**TERRA NOVA ENGINEERING, INC.**

***PLATTE SELF STORAGE***  
***AREA RUNOFF COEFFICIENT (C) SUMMARY***

# **PLATTE SELF STORAGE**

## **SITE DEVELOPMENT PLAN**

**Figure 8-12. Inlet Capacity Chart Sump Conditions, Curb Opening (D-10-R) Inlet**

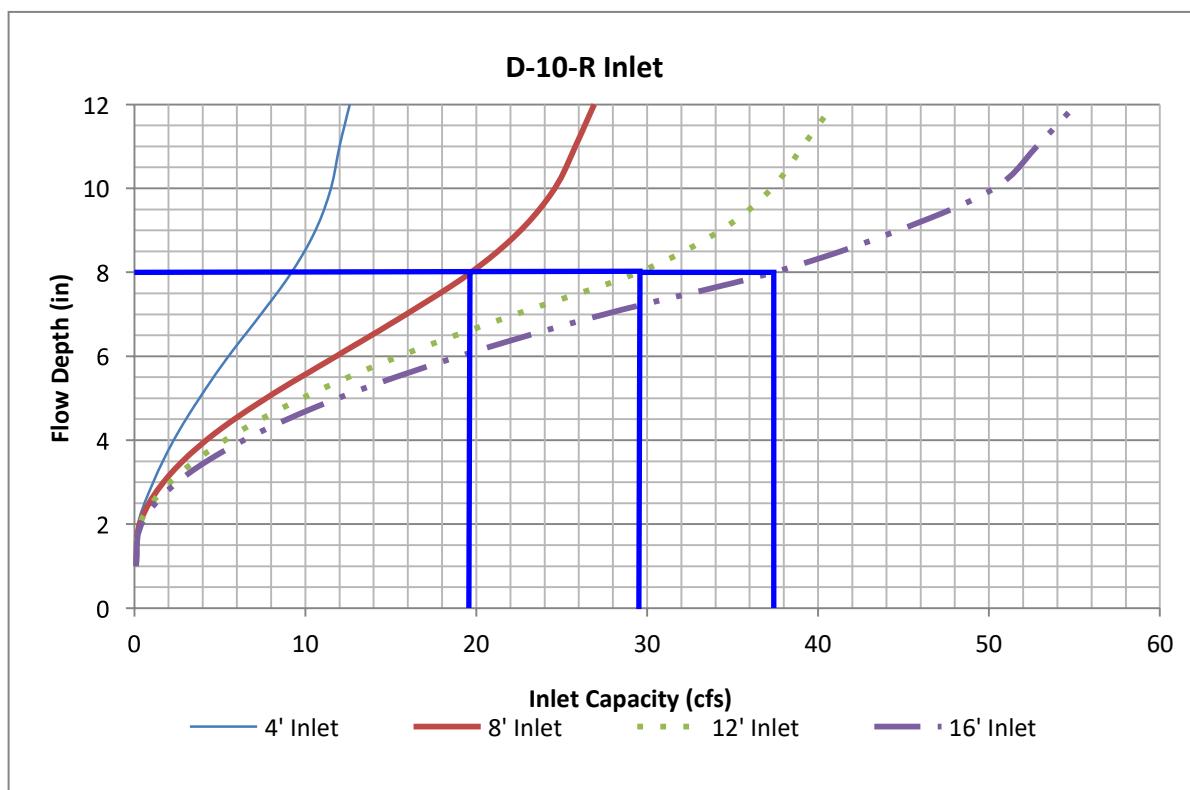
D-10-R inlets are used in the city. County uses CDOT Type R inlets. Please revise

MHFD Inlet spreadsheet has all 3 inlet types available (Type R, Type C and Type 13). Suggest using that spreadsheet for inlet design.

changed to Type R and updated calcs with correct chart for Type R and Type C

used for type 13 inlets that have by-pass flows at DP3A-3D

## Pond Outlet

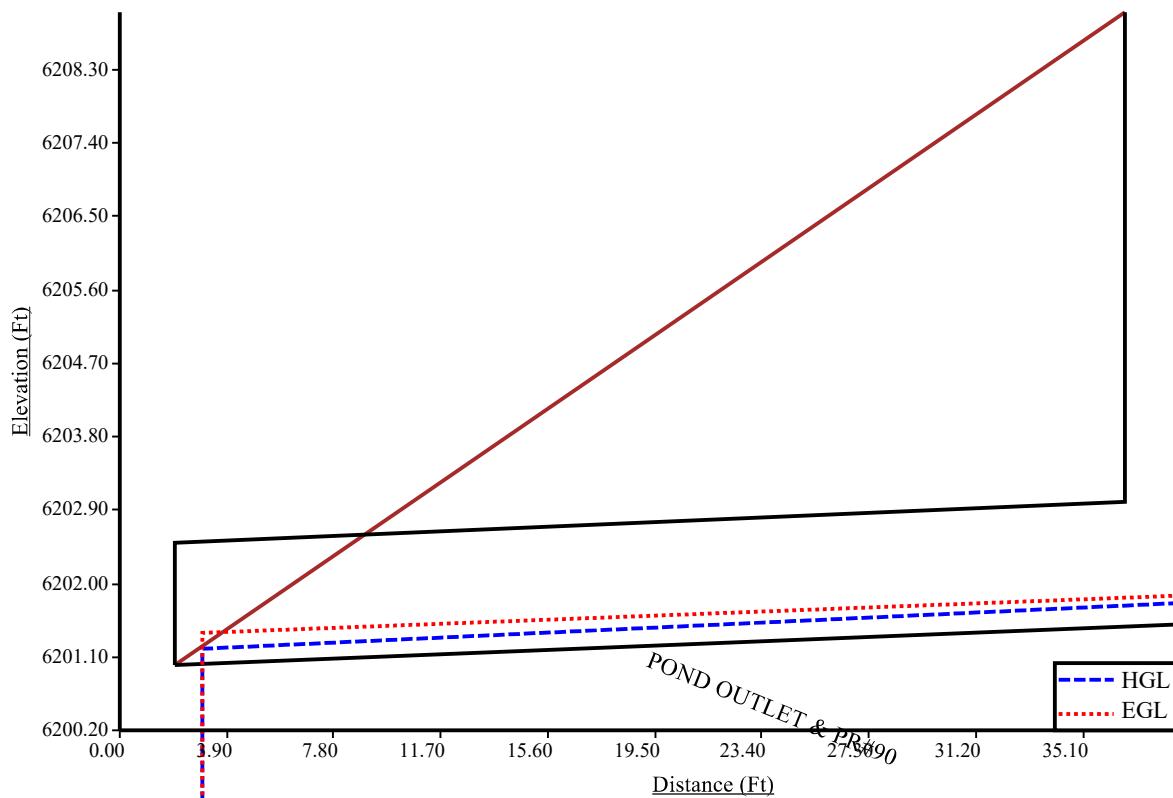
Why do these lines drop off? Verify input information

fixed

### PROPOSED DRAINAGE MAP

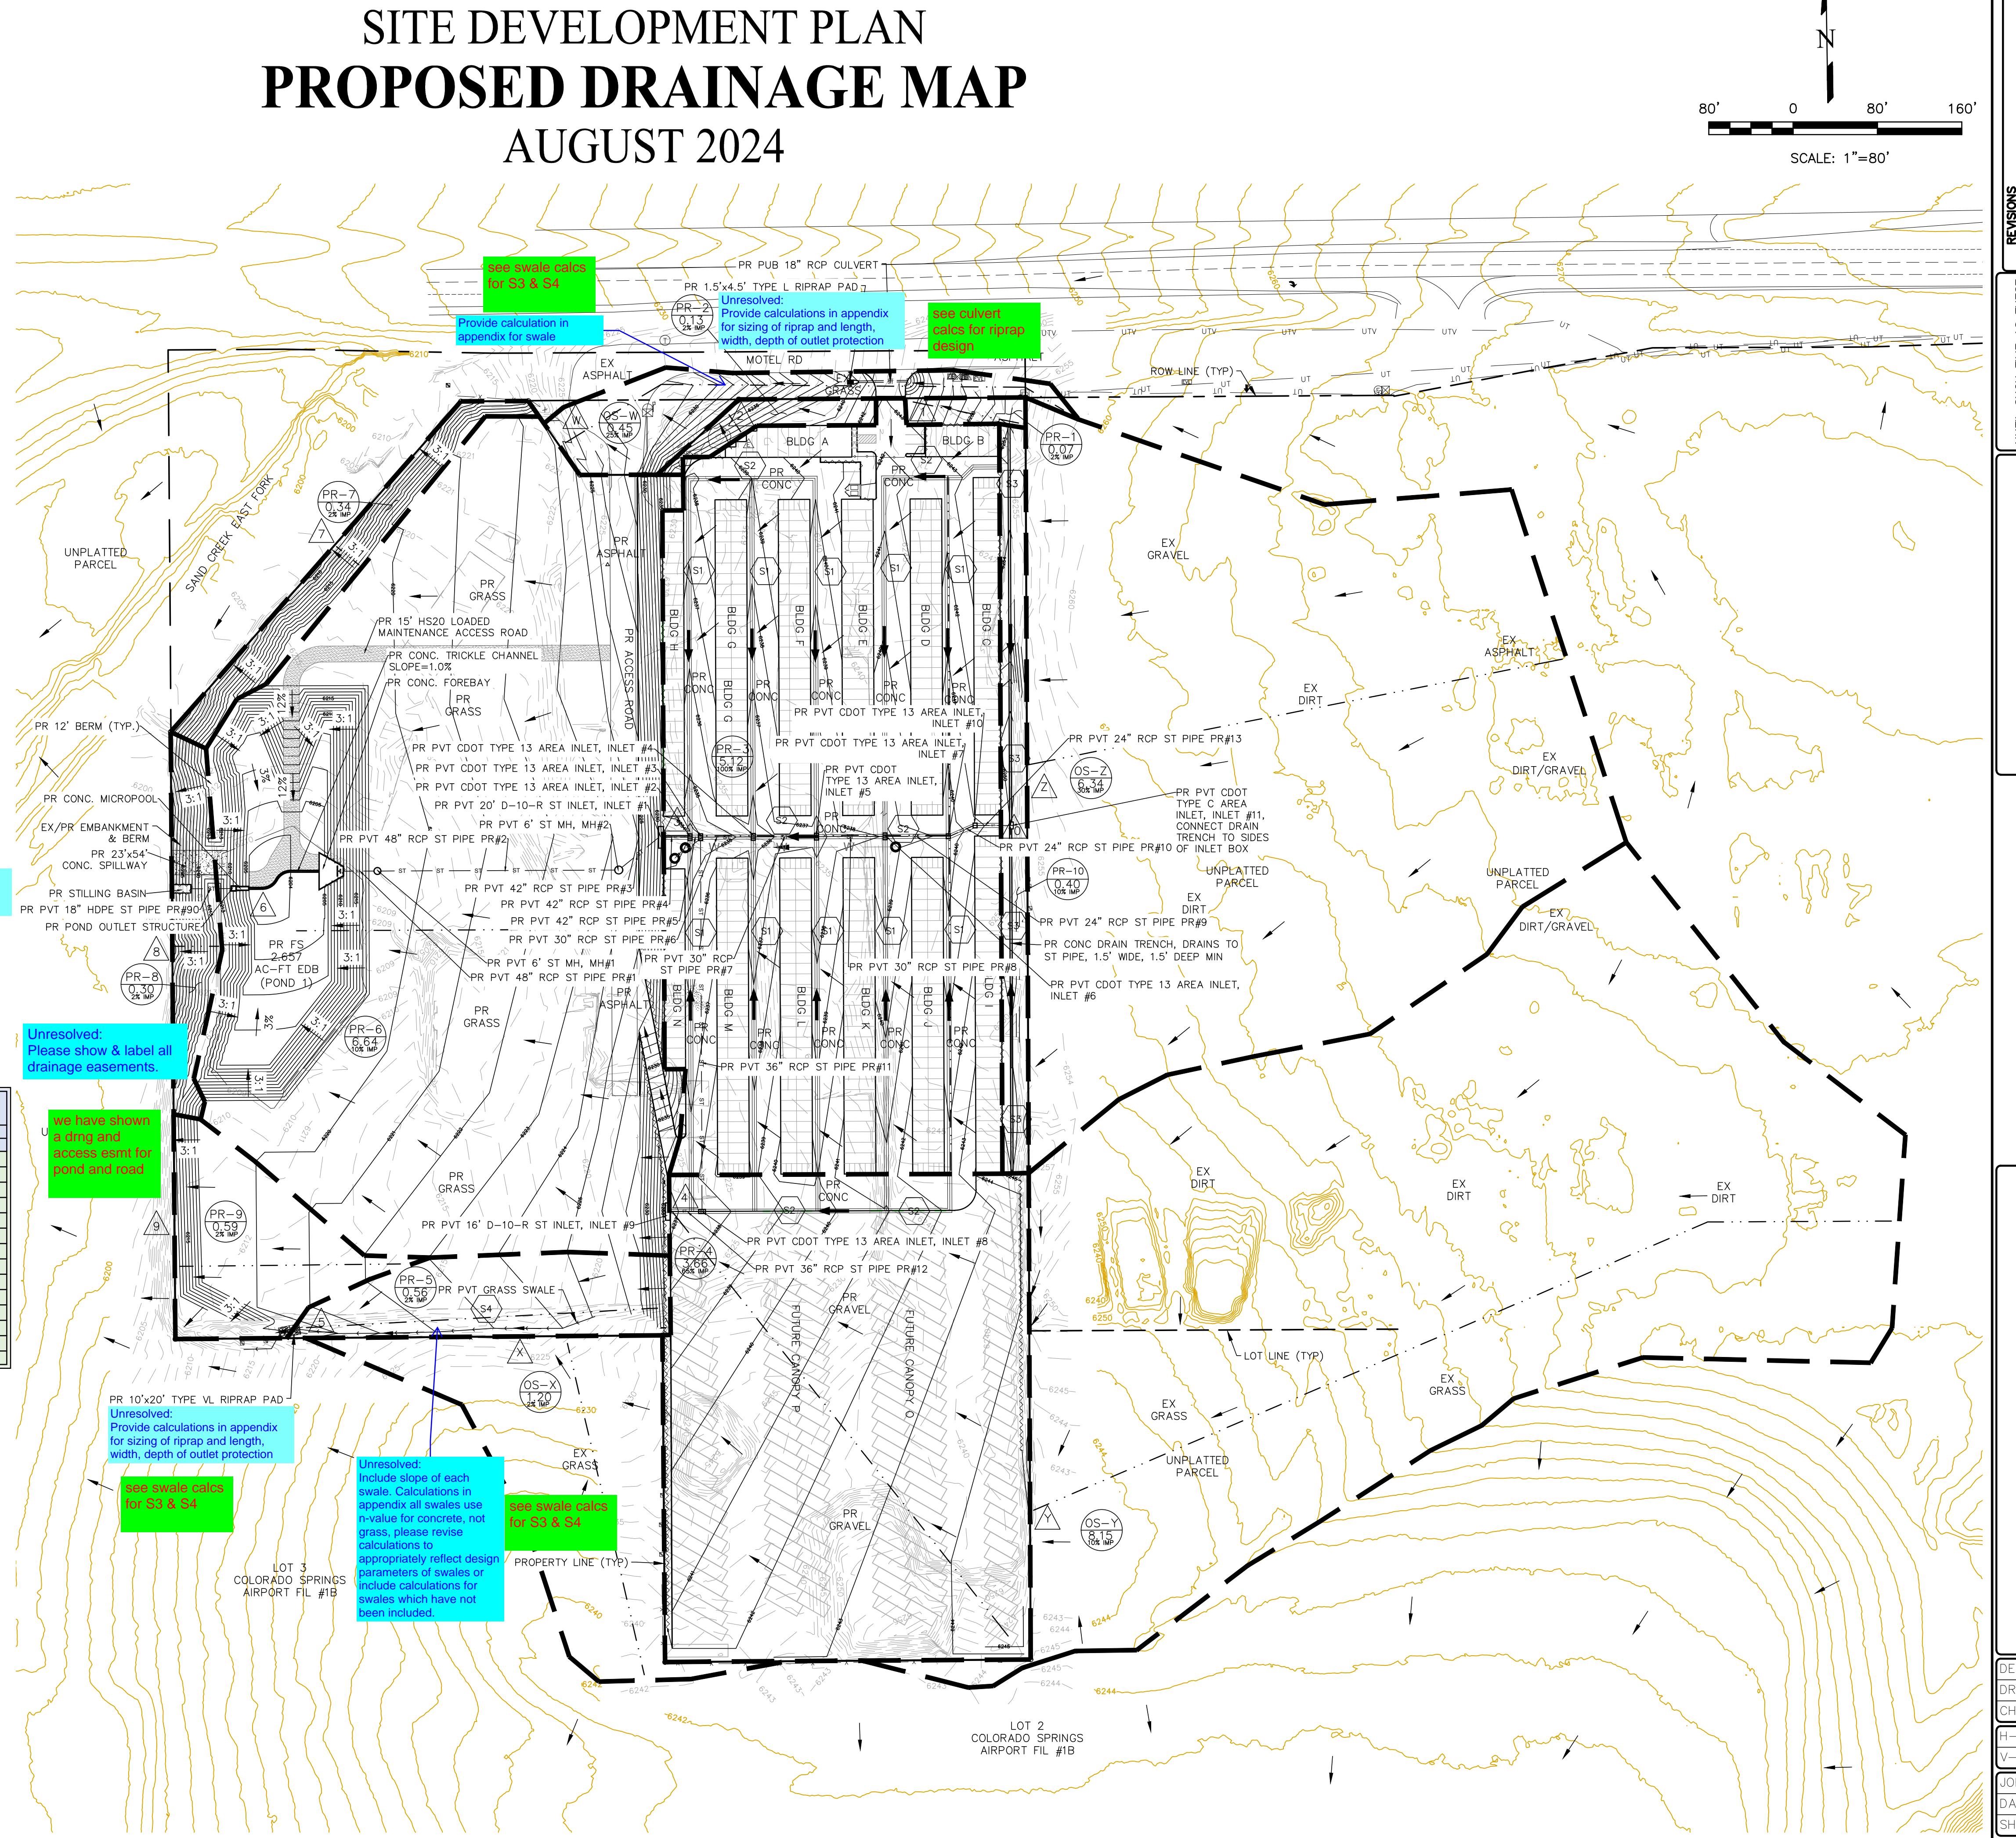
Unresolved:  
Provide calculations in appendix  
for sizing of stilling basin

Unresolved:  
Please show & label all drainage easements.

see appendix  
for calcs

We have shown  
a drain and access route for  
pond and road
